Re: Compliance Submission in respect of a Permission for the Construction of 347 No. Residential Units and all Associated Site Development Works at Tandy's Lane Village Development Area, Lucan, Co. Dublin (Tandy's Lane Phase 2)

SDCC Reg. Ref. SDZ22A/0006

Compliance Submission – Condition 13(a)(iii), 13(a)(v), 13(a)(vi), 13(c), 13(d), and 13(e).

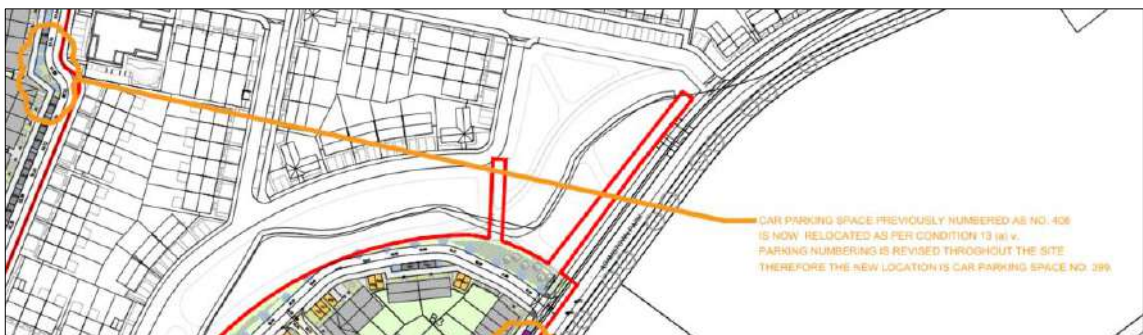
- **13 (a)(v) "Provide a drawing demonstrating the relocation of car parking space No. 408 to be for easier access."**

"Details of refuse collection areas as raised in the submitted Road Safety Audit and any other safety issues raised. Car parking space no. 408 shall be revised so that it would be easier to access."

In response, we note that car parking space No. 408 was relocated in the previous submission in comparison on the application layout. We have submitted the Car Parking Strategy by MOLA Architects for clarity. Please see extract from MOLA Architects drawing below:

We have been advised by Waterman Moylan that this parking space does not have any accessibility issues.
